Comments related to planning application number 2020/62/91838/W

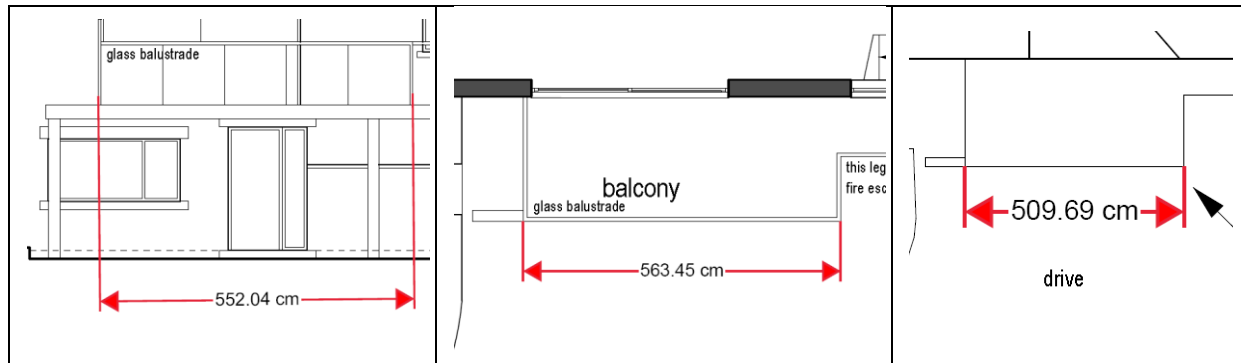
The proposed terrace support posts have a side that faces the front elevation, and an opposite side that faces the highway. You might expect, measuring the shortest distance from the front elevation wall, to each of the support post faces, would provide the same result, when using the different proposed drawings. However, they don't.

Elevation	Inner face	Outer face
Side	174.83cm	194.73cm
Ground floor	237.49cm	255.28cm
First floor	201.52cm	221.82cm
Site plan	229.49cm	249.77cm

Measuring the length of the proposed terrace (excluding fire leg) yields equally baffling results:

Elevation	Inner face
Front	552.04cm
First floor	563.45cm
Site plan	509.69cm

Which, if any, of these measurements are meant to represent what is being applied for?

The terrace being applied for could be 9.9m^2 or 14.4m^2 (45% more) . Who really knows?

- I. It is completely unclear what size terrace is being applied for. The plans are inaccurate, contradictory, unreliable, and unusable. As such, they are completely inadequate for making any decision.

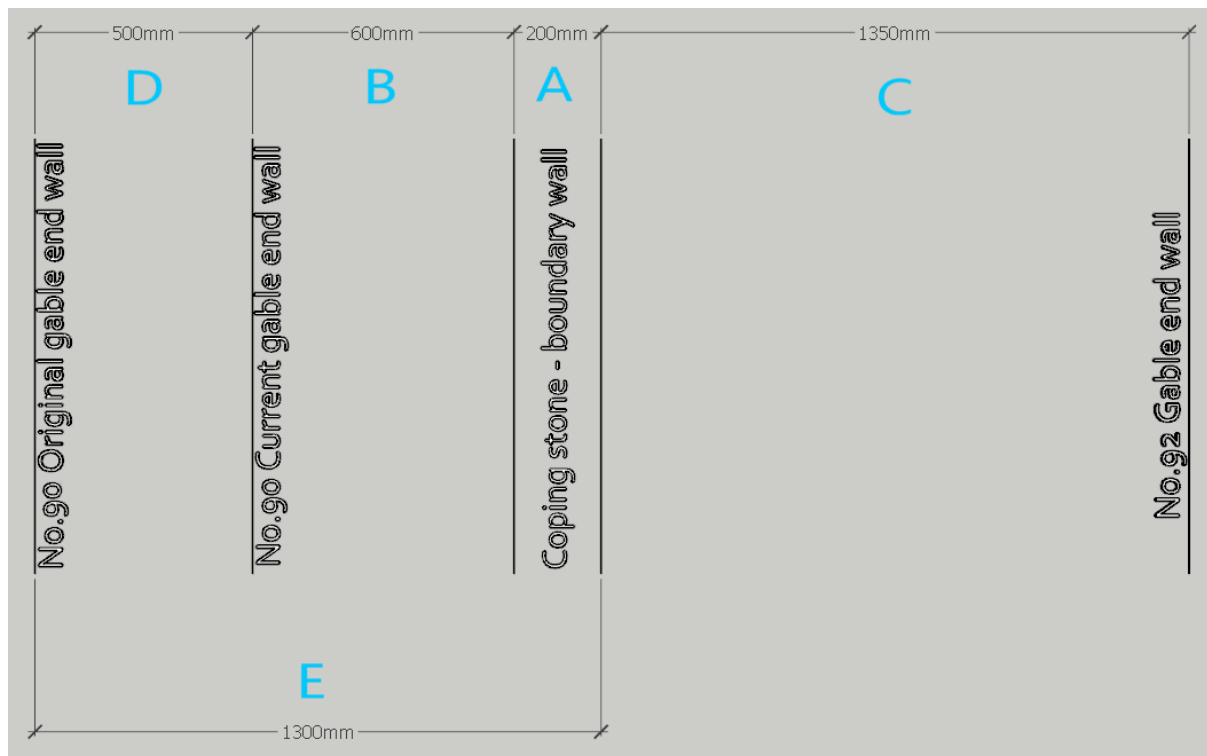
The earlier development, to no.90, not only changed the front door to a window, it also moved the western gable end wall closer to no.92. As can be seen in the image above, to the left, originally, there was sufficient room, between the dwelling and the boundary, to facilitate a walled gate. Moving the gable end wall, at no.90, reduced the width, of the side path, considerably. This is

illustrated below, which represents a top view of the gap between the opposing gable ends of no.90 and 92.

Figure A (200mm) represents the width of the coping stones that lie atop the existing boundary wall. Figure B (600mm) represents the maximum size of the existing pathway between the boundary wall and the gable end of no.90. Adding figures A and B provides a total of 800mm, which compares less favourably to the measurement between the gable end of no.92 and the boundary wall, shown as figure C (1350mm). However, when you consider the original gable end of no.90 was 500mm (figure D) further away from the boundary wall, we see no.90 originally had an (almost) equivalent gap between the boundary and gable end, of 1300mm ($500 + 600 + 200$) (figure E).

This further illustrates the boundary, as depicted on the submitted plans, is inaccurate and incorrect.

Existing front elevation

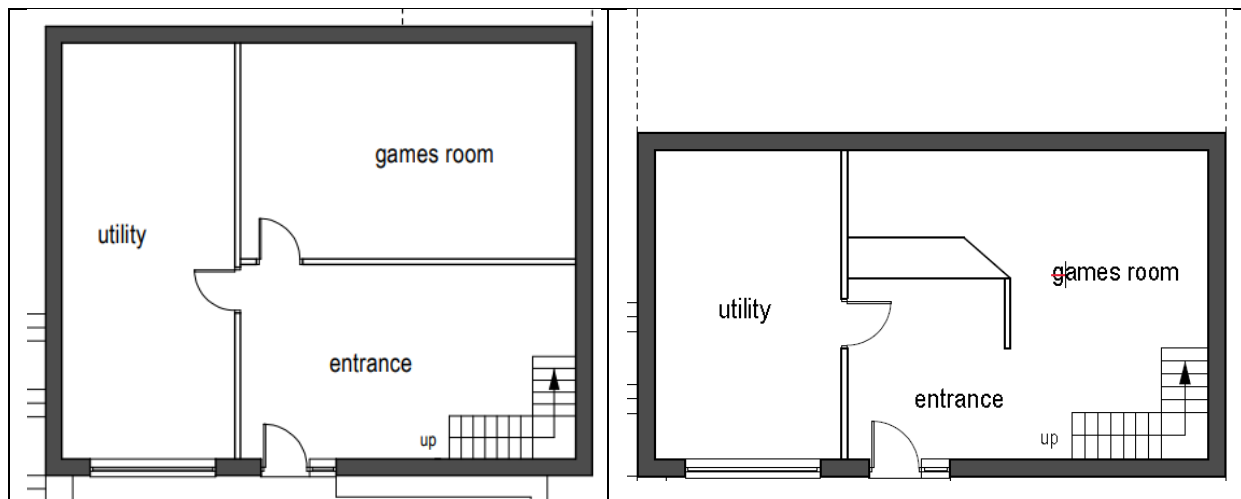
Two images can be seen below. The picture of the left is how the applicant shows the existing front elevation. The picture on the right depicts how the existing front elevation actually looked, prior to any changes being made.

The original property had stone steps, on the front elevation. These steps led, from the owners drive to what would have been the very original front door. That door was removed by the previous owner, when extending his property. The applicant removed the steps and walkway, to create the new front door at ground level. A retaining wall, identified as 'stone wall', in the submitted existing image, was created after the steps and walkway were removed.

By retaining the majority of the external steps and walkway, but starting the steps 1.5m to the right, the applicant could have changed the right hand first floor window, into a new front door. By doing so, it would have retained the existing fire escape route, from an open lounge.

- I. The existing plans do not follow the guidance concerning accuracy, as they are inaccurate. The existing image does not reflect how the property originally appeared.

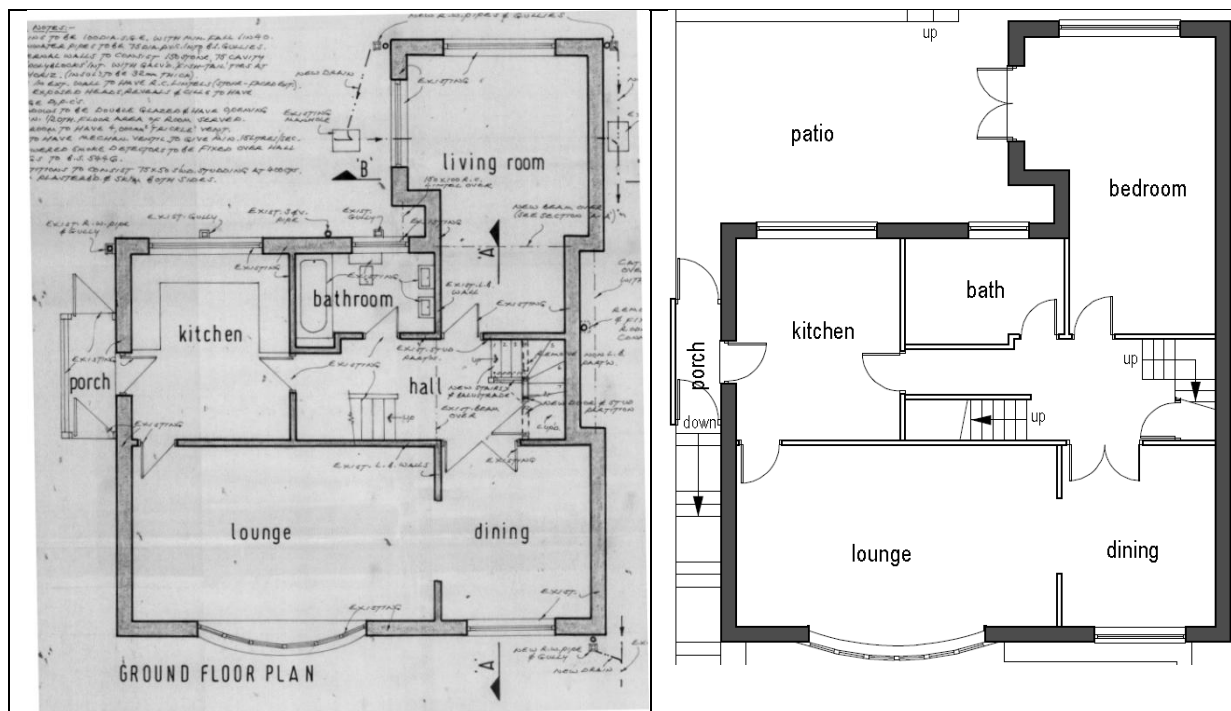
The two images above show the original and revised basement plans. The left most image shows the basement excavation taking the back wall the full depth of the building. The right most image shows the extension only going as far back as the original garage did.

The two plans are hardly close. They are hugely different. Perhaps the designer was working blind, but how the vastly different room configurations, walls and dimensions could be mistaken is intriguing. If the designer were working blind, as in never having visited the property, one has to ask what can be taken as accurate elsewhere in the plans. If the designer had visited the property, one has to ask how such a mistake could have occurred and whether anything else is accurate.

The lack of accuracy here, and elsewhere in the submissions, is, for me, concerning. Stakeholders are being asked to comment on matters that have long-term consequences, based on, at times, consistently inaccurate plans. I have little confidence, in what is being presented.

The missing wall

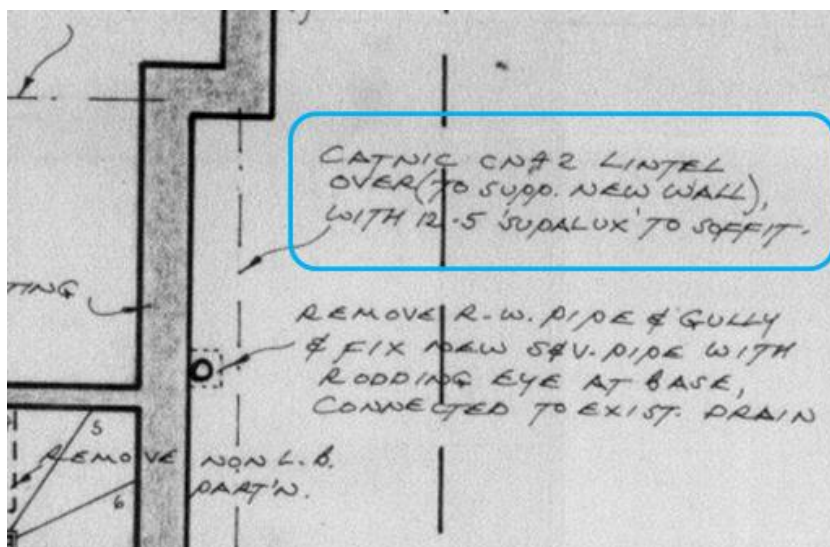
Above you'll see two images. On the left is a plan from planning application 94/62/91515/W1. That image was submitted in 1994 for the changes the previous owner made. The plan on the right is the existing plan from the current applicant. As such, they should be the same. They are not.

There are a few small differences, but one I suggest is significant; concerning the right hand wall. In 1994, part of the original gable end wall is shown to be retained and appears indented, to the left, compared to the walls to the front and rear. In the current applicant's plans that indented wall is missing.

Opaque glass for no.92. Not.

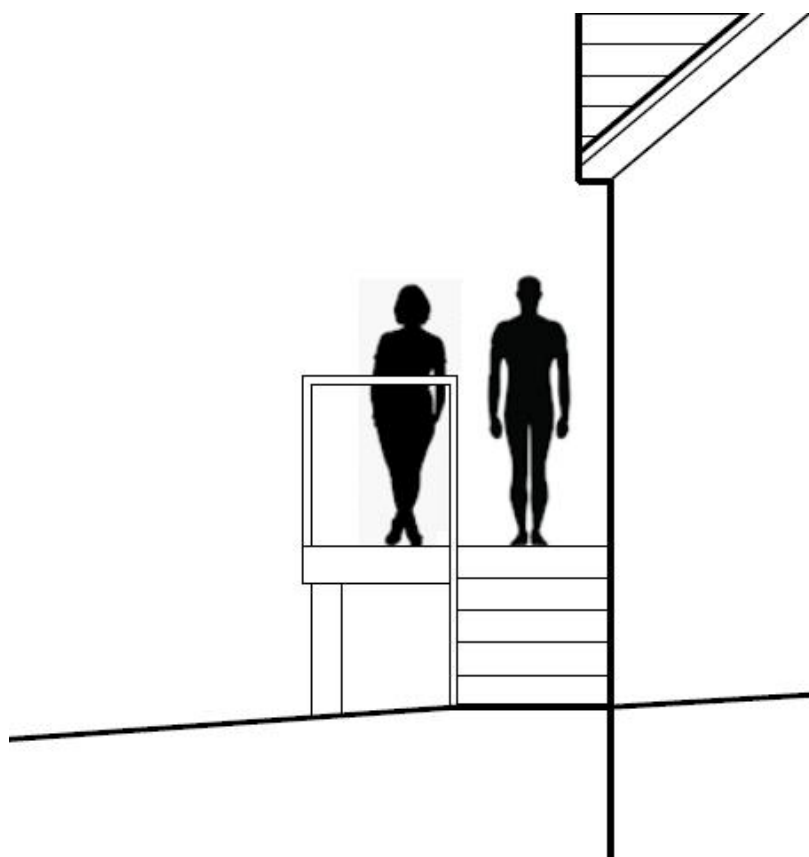
The height, to the top of the balustrade, on the side of no.92 is proposed to be 110cm. This is 40cm lower than on the side of no.88. The glass is proposed to be clear, on the side of no.92. The glass is proposed to be opaque, on the side of no.88. The opaque glass, on the side of no.88, is proposed to cover the whole side of the proposed terrace. Over half of the opening, on the side of no.92, is proposed to be completely exposed.

- I. The overlooking and loss of privacy, for no.92, is not being given the same level of consideration as no.88.
- II. Any fire escape route leg should land on the drive of no.90, being the quickest and safest route: as per fire regulations.
- III. Opaque glass, the same height as no.88 should be proposed on both sides of the proposed terrace, such that users of the terrace cannot be seen from either neighbouring properties.

Distance

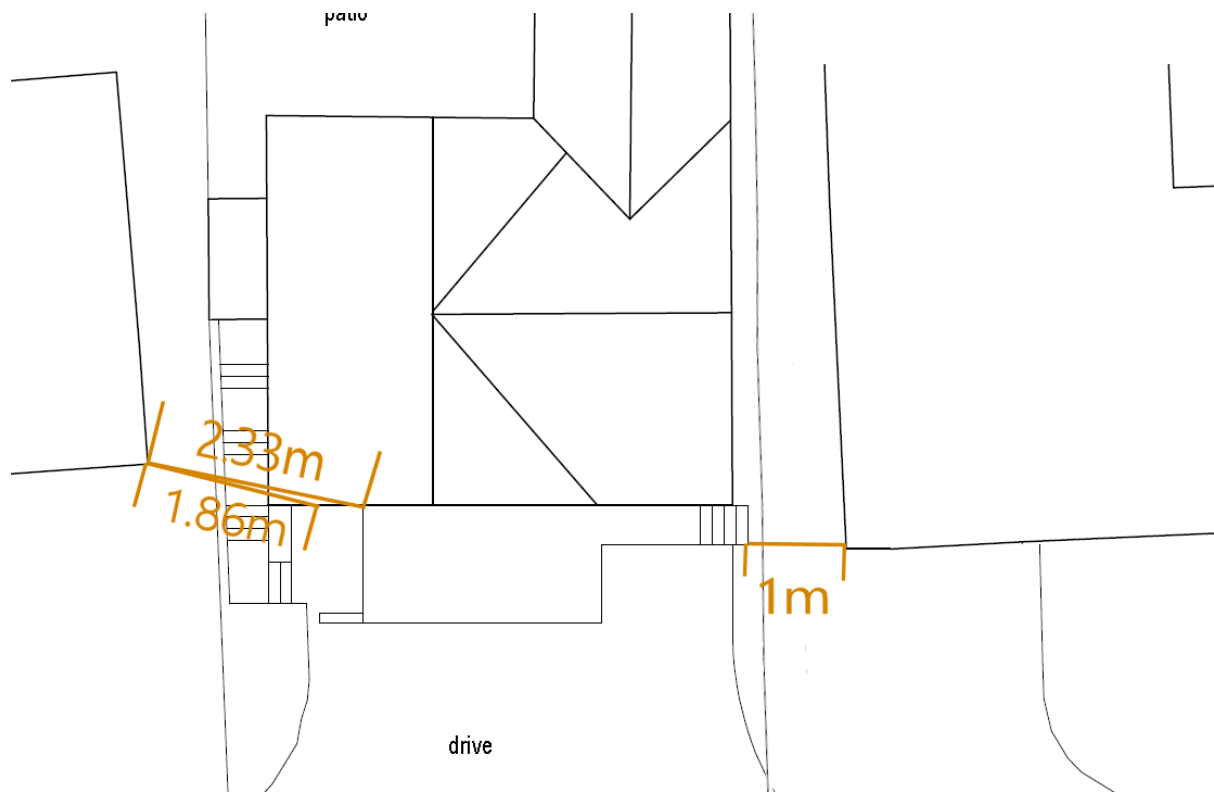
Previously, the distance between the proposed terrace and no.88's dwelling, was 186cm. This was subsequently increased to 233cm. The distance between the proposed terrace and no.92's dwelling is 100cm. The distance to no.88 was, presumably, increased to tackle overlooking and loss of privacy.

- I. The fact the proposed terrace is intended to be almost twice as close to no.92, as to no.88, means our overlooking and loss of privacy is not being equally considered.

Stone wall - Garage door

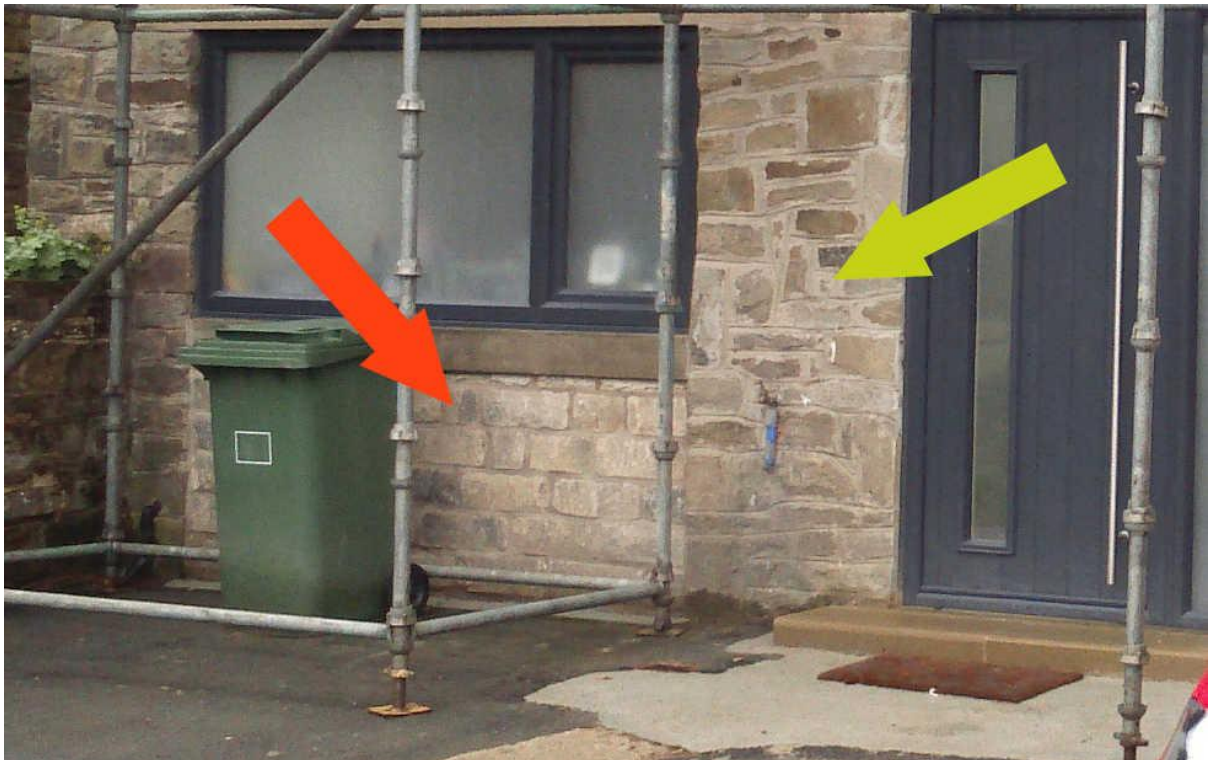
The original garage door has been replaced; half with a window, half with a stone wall. The stone is not random shapes, being more squarely cut. The stone does not attempt to follow the same course of stone work, evident on both sides.

The photograph below shows the original random stone (green arrow) and the new square cut stone (red arrow). The distinction between the two could not be more obvious.

Use of this square shaped stone, instead of matching random stone, seems an ill conceived solution.

- I. The incorrect finishing materials stonework, replacing the garage door, negatively affects the visual appearance of the property.
- II. In my opinion, this level of design and choice of material is unacceptable, as it negatively impacts the character and appearance of the area. I suggest it should be replaced.

Fire leg

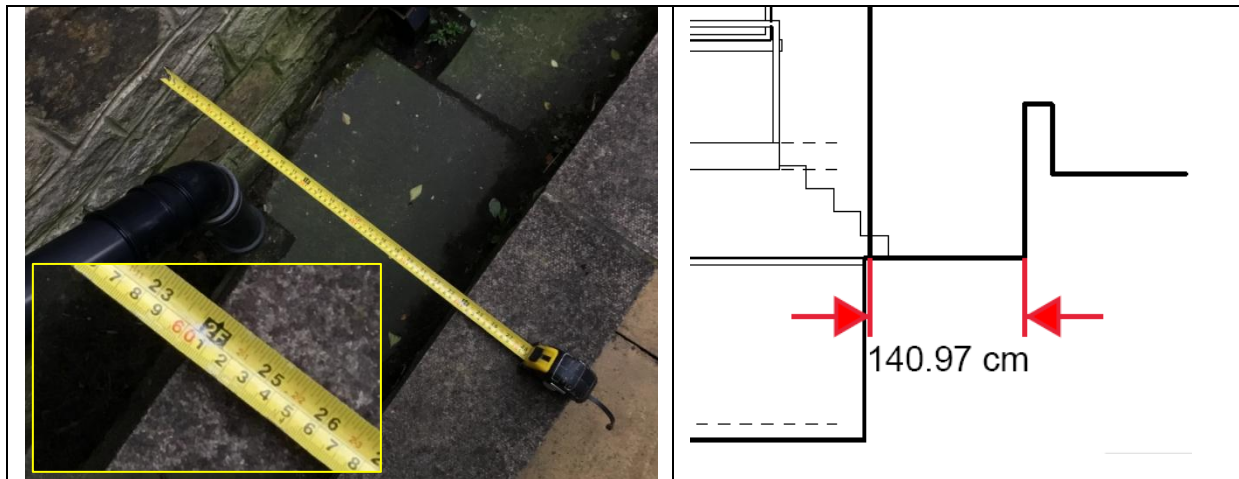
The proposed fire escape route is not much wider than an ironing board. I can imagine the ironing board has benefited from a greater level of safety and design considerations having been applied to it than, I would suggest, has been afforded to the proposed fire escape route.

Despite the width, of the escape route path, having been previously highlighted as only 50-60cm, and the submitted plans showing it to be 141cm, it has not been corrected in any of the two further submissions. From this, I can only assume the fire safety route is not being afforded the care and consideration it warrants.

The applicant should change his internal staircase, to make it fire secure or have the fire escape route land directly on his drive.
